Docket Item # 8 & 9
BAR CASE # 2010-0361/362

BAR Meeting
January 5, 2011

ISSUE: Permit to Demolish/Encapsulate and Alterations

LOCATION: 313 South Columbus Street

Figure 6. Proposed replacement window specifications.

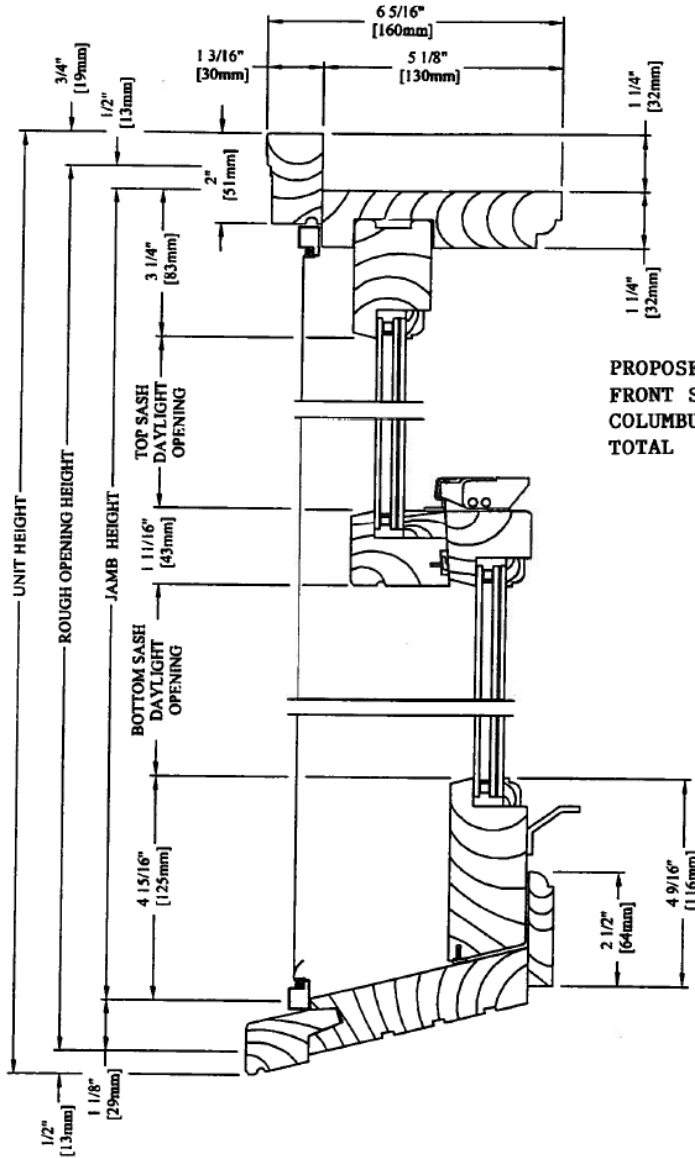
However, Staff cannot support the replacement of the six original windows on the main block. The recently adopted *Window Policy* states that “all original or previously replaced windows with either mortise and tenon (“pegged”) sash joinery, or with cylinder (“wavy”) glass must be repaired and retained.” Staff visited the property and found that these original two-over-two sash windows are in very good condition and are protected by well maintained aluminum storm windows. The applicant has provided supplementary material as to why these windows must be replaced, stating that during previous renovations the windows were altered — the weight pockets were filled with blocking and small parts of the window sash were removed, preventing them from being easily operable.

While the windows have been modified, Staff does not find that the previous modifications warrant the wholesale replacement of these historic windows. Staff maintains a list of historic window restoration specialists who are able to assist in repairing the existing sash and making them operable. Operable sash windows did not have pockets for sash balance weights until the second half of the 19th century and the sash were supported by jamb cleats or cams which could be adopted on these windows. If there are problems with drafts, Staff recommends new weather stripping and, if necessary, replacement storm windows with low-e glazing film to increase the homeowner's comfort.

STAFF RECOMMENDATION: Staff recommends denial of the replacement of the six original windows on the main block and approval of the remainder of the application with the following condition:

Figure 7. Proposed alterations.

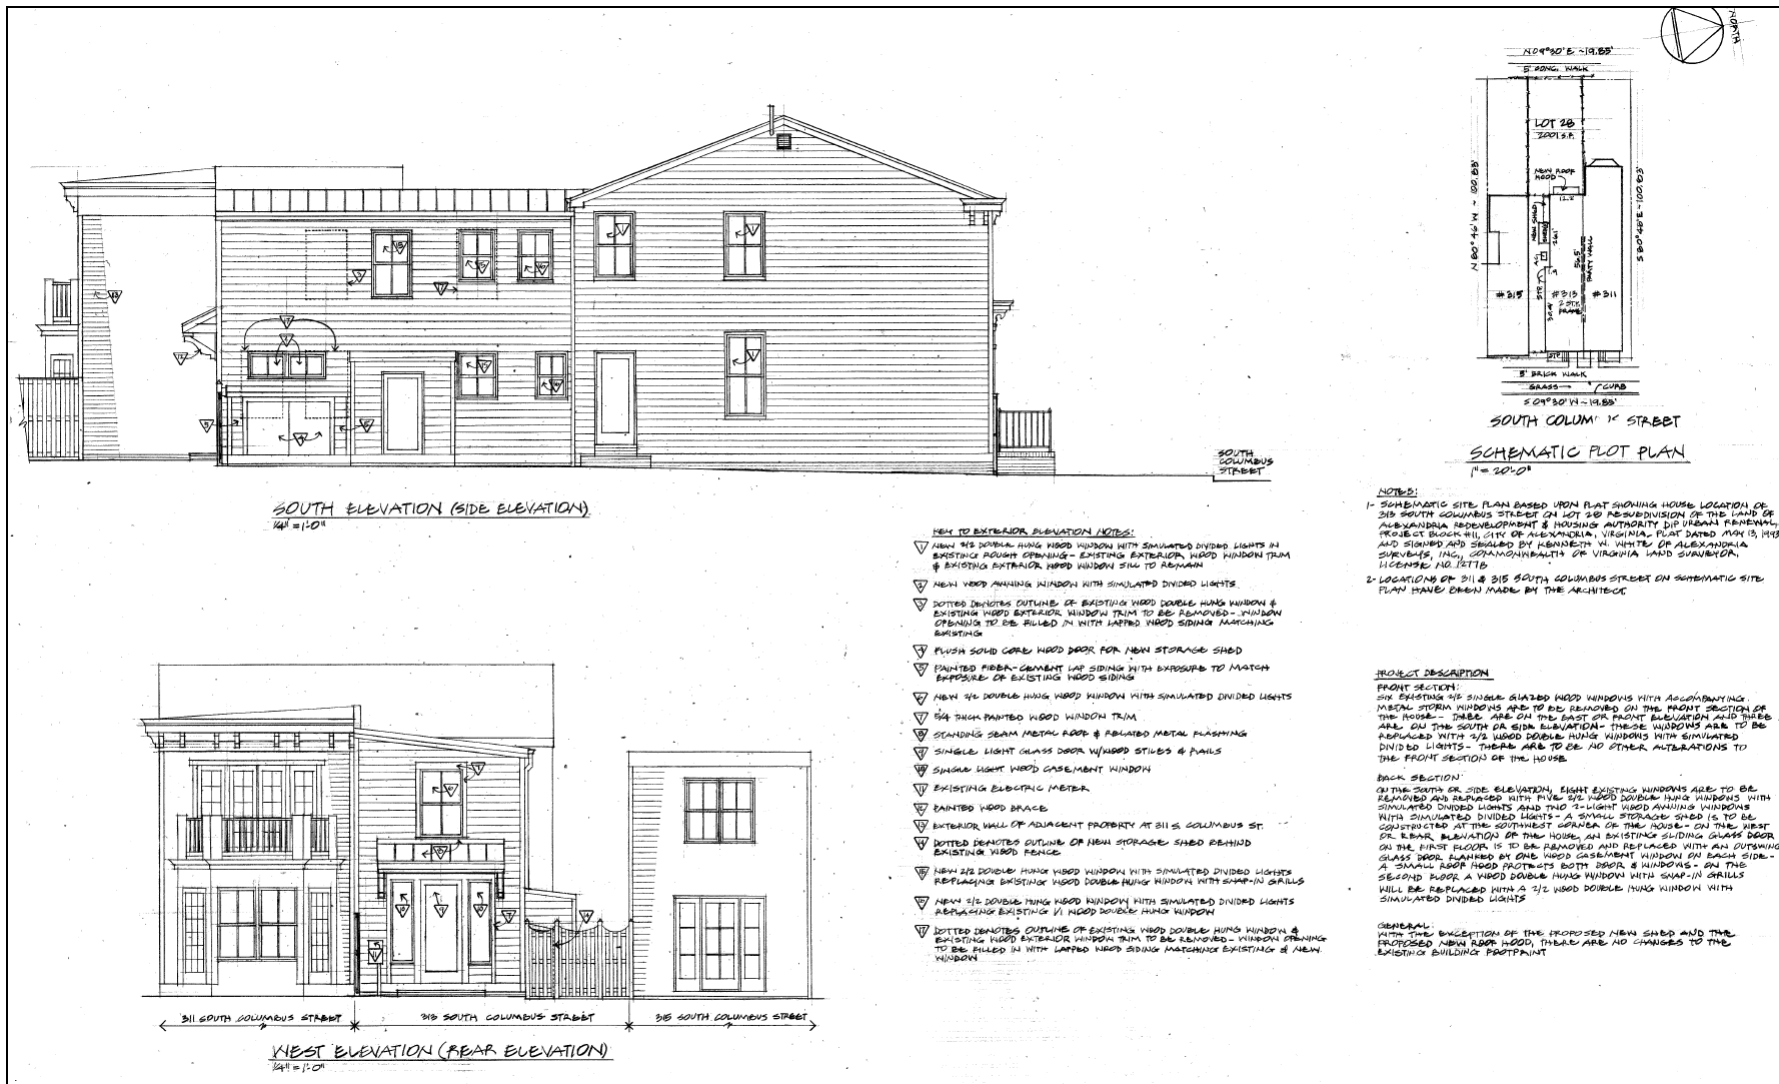
Staff supports the majority of the proposed alterations including the addition of a small storage shed and the changes to the rear first-story door. Staff does not object to the filling in of an existing window on the rear ell or the conversion of two double-hung windows to awning windows in this same area, noting that these alterations reflect common, minor changes made to buildings over time to adapt to changing needs. The replacement of the non-historic windows on the rear ell with simulated divided light, double-glazed wood windows in a more architecturally appropriate style is a significant improvement. Staff notes that the windows on the rear ell are functionally not visible from the public right-of-way since the alley immediately behind the property is privately owned.
